ADDENDUM NO. 01

RANKIN TRAILS AMPHITHEATER AND BASEBALL PARK

Rankin County, Mississippi

WBA Proj. # 2215/2315

C1.11

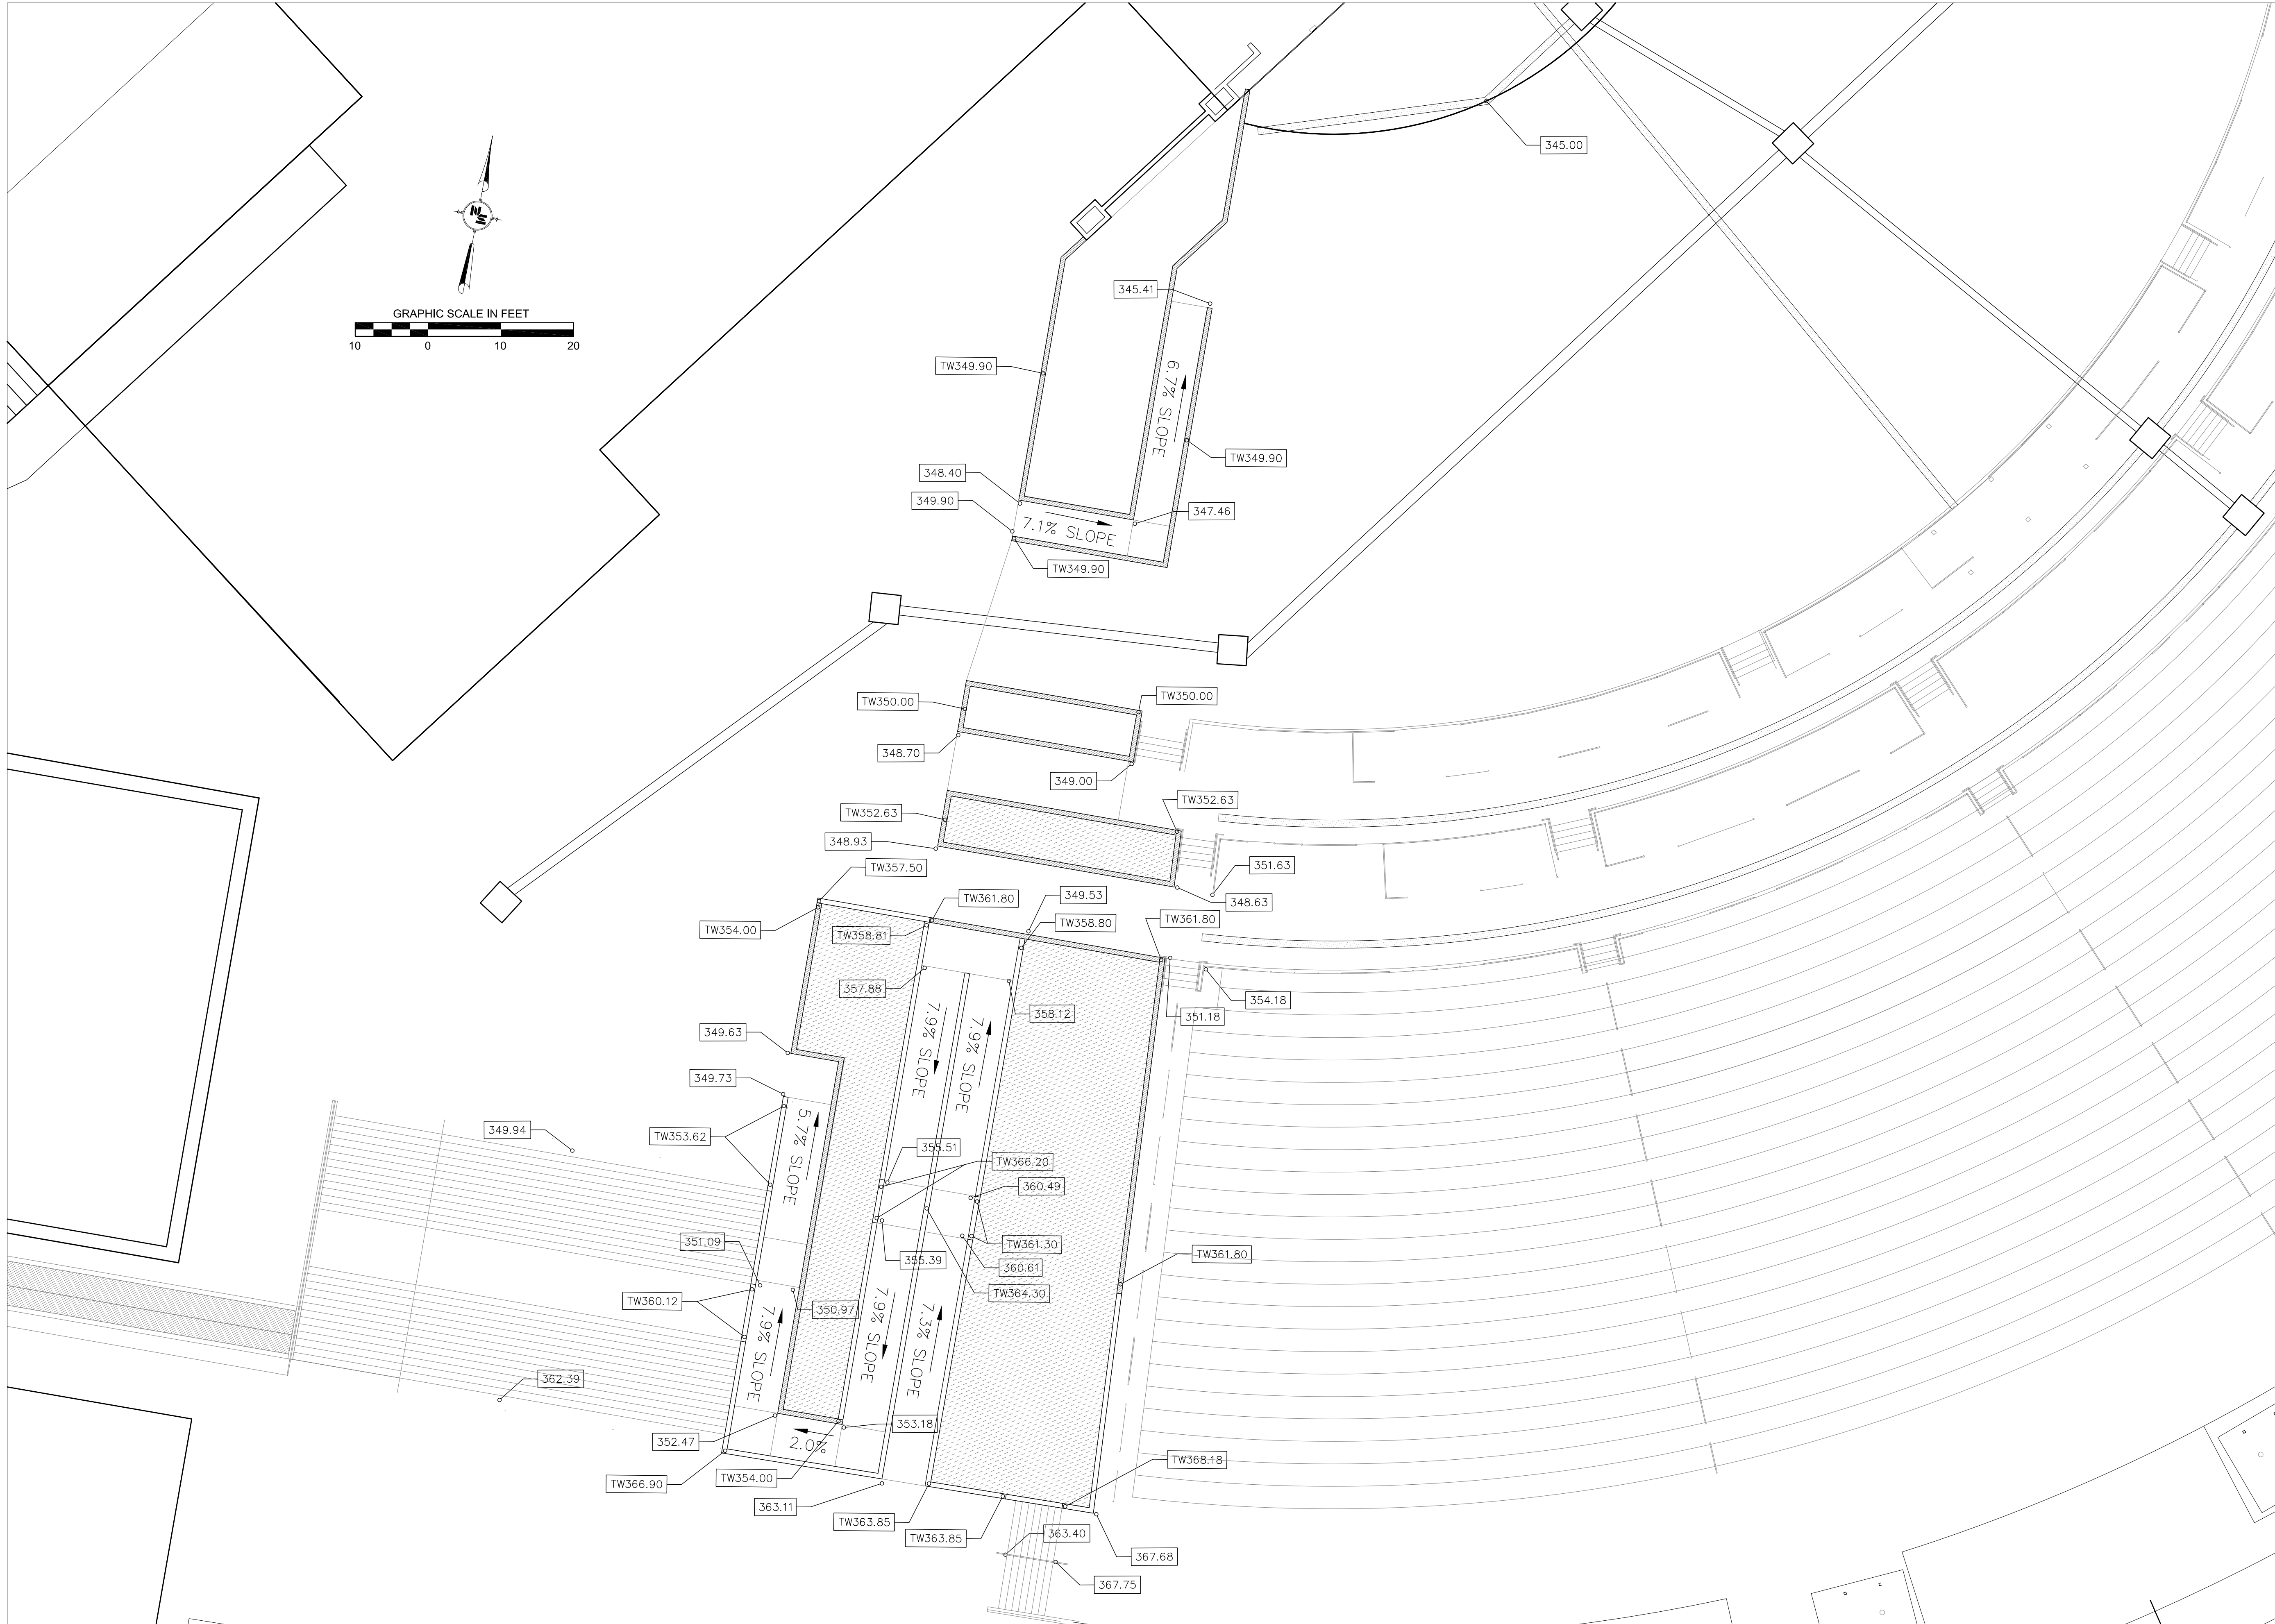
ADD top of wall detailed grades, per enclosed revised sheet C1.10.

C2.1

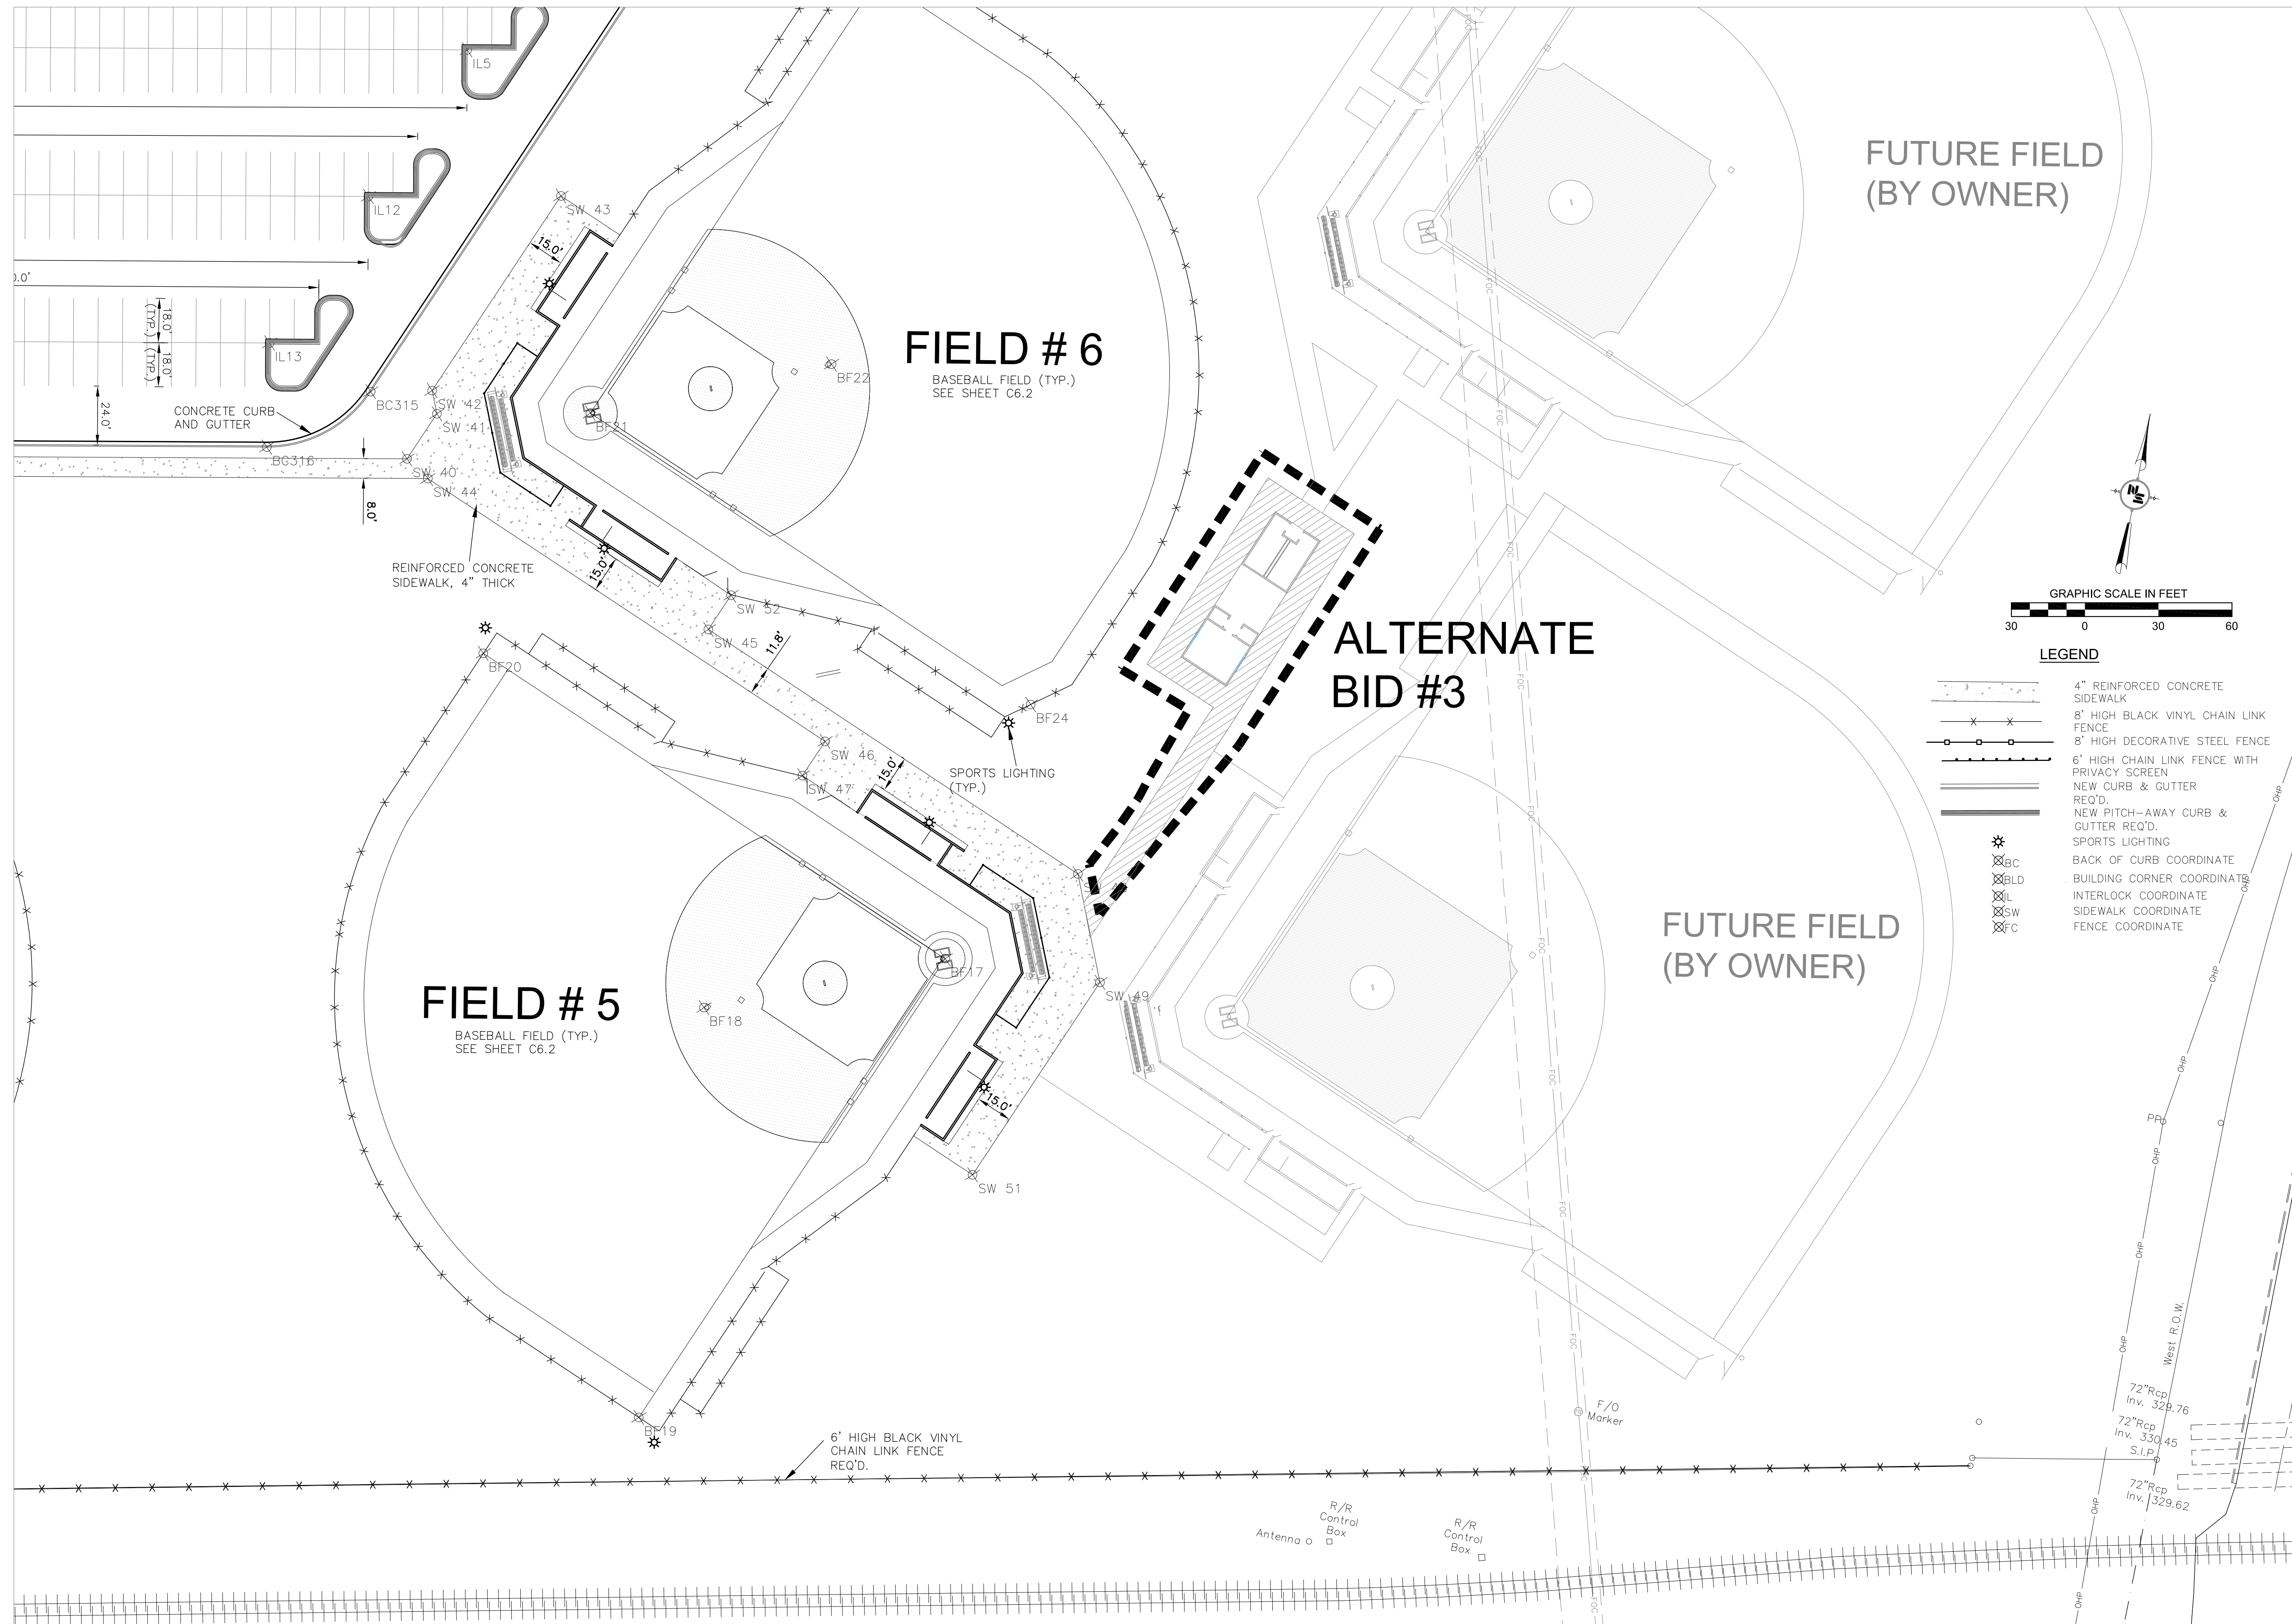
- ITEM NO. 7** **SHEET C1.11 GRADING AND DRAINAGE PLAN**
ADD sheet C1.11.
- ITEM NO. 8** **SHEET C2.1 SITE DIMENSION PLAN**
REVISE numbering of Alternate Bids #3 and #4, per enclosed revised sheet C2.1.

S1.0

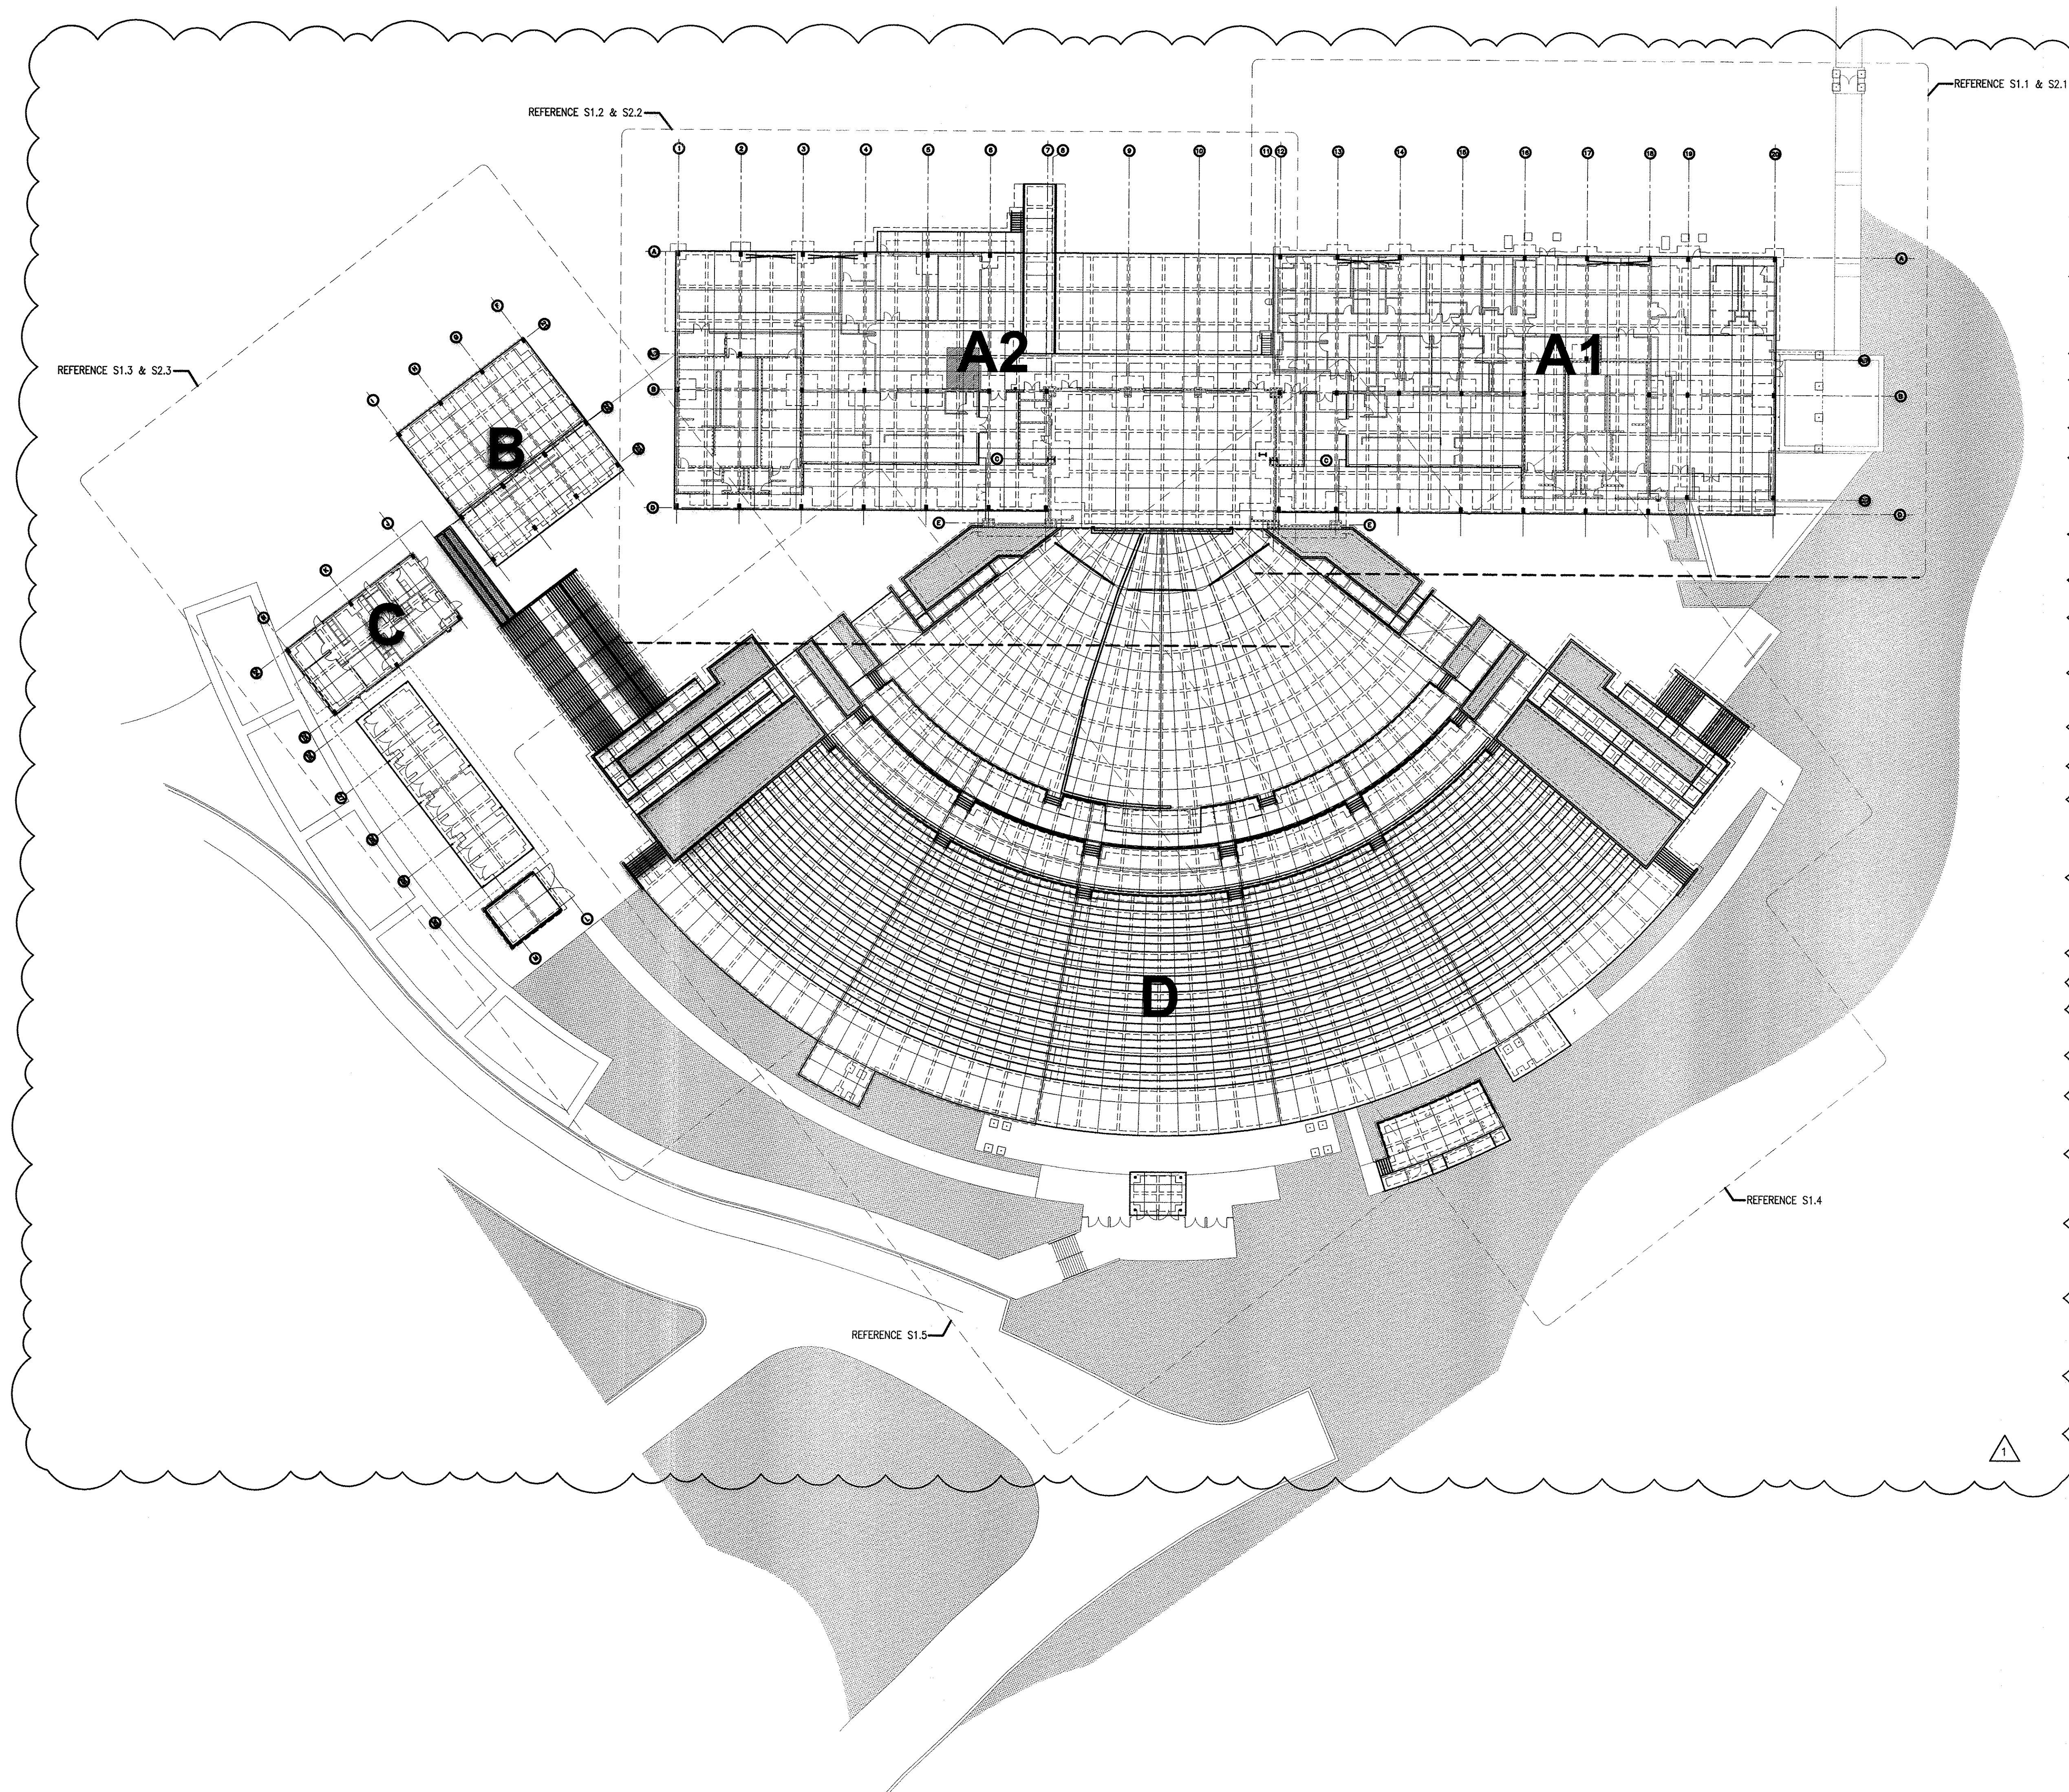
- ITEM NO. 9** **SHEET C2.2 SITE DIMENSION PLAN**
REVISE numbering of Alternate Bids #3 and #4, per enclosed revised sheet C2.2.
- ITEM NO. 10** **SHEET S1.0 OVERALL PLAN**
ADD building labels and sheet references, per enclosed revised sheet S1.0.
